WATTS BAR NUCLEAR PLANT (WBN) UNIT 1 - CORE OPERATING LIMITS  
REPORT (COLR) FOR CYCLE 7, REVISION 3

The purpose of this letter is to provide Revision 3 of the  
Cycle 7 COLR in accordance with WBN Technical Specification  
5.9.5.d. Revision 3 revises the maximum W(z) values and was  
effective as of September 19, 2005.

WATTS BAR NUCLEAR PLANT, UNIT 1, CYCLE 7

Revision 3

Figure 4  
RAOC Summary of Max  $W(z)$  at 150 MWD/MTU  
with HFP AFD Band of -12/+6 %  
(Top and Bottom 10% Excluded)

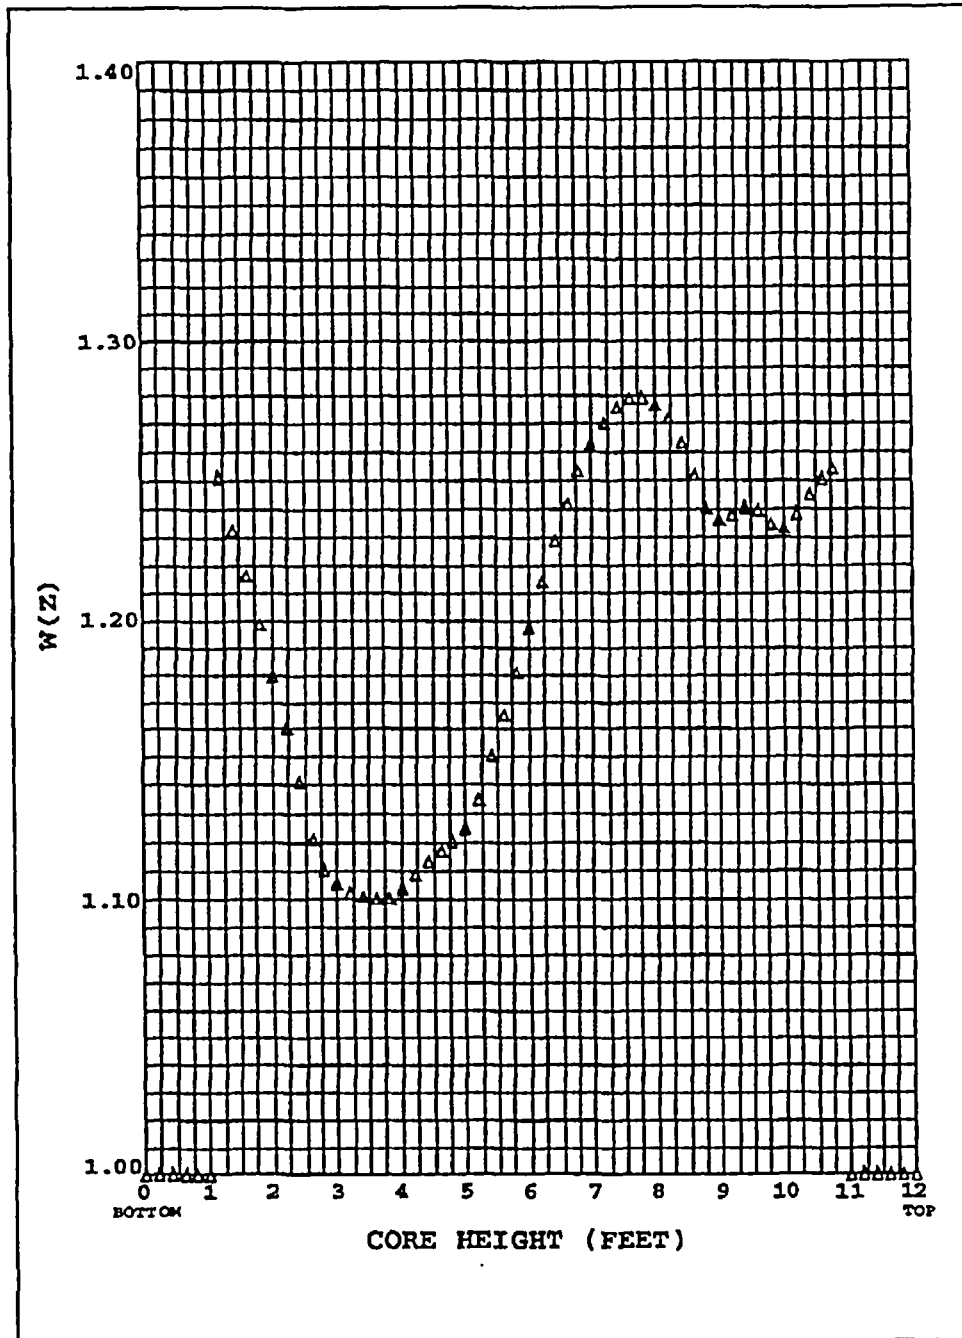
Revision	Date of PORC Approval	PORC Meeting Number	Affected Pages	Reason for Revision
0	3/11/05	4073	All	Initial issue
1	3/18/05	4075	All	Revised to remove cycle 7 restriction to mode 6
2	5/31/05	4089	1, 9 - 12	Revised maximum W(z) values
3	9/19/05	4107	1, 9 - 12	Revised maximum W(z) values
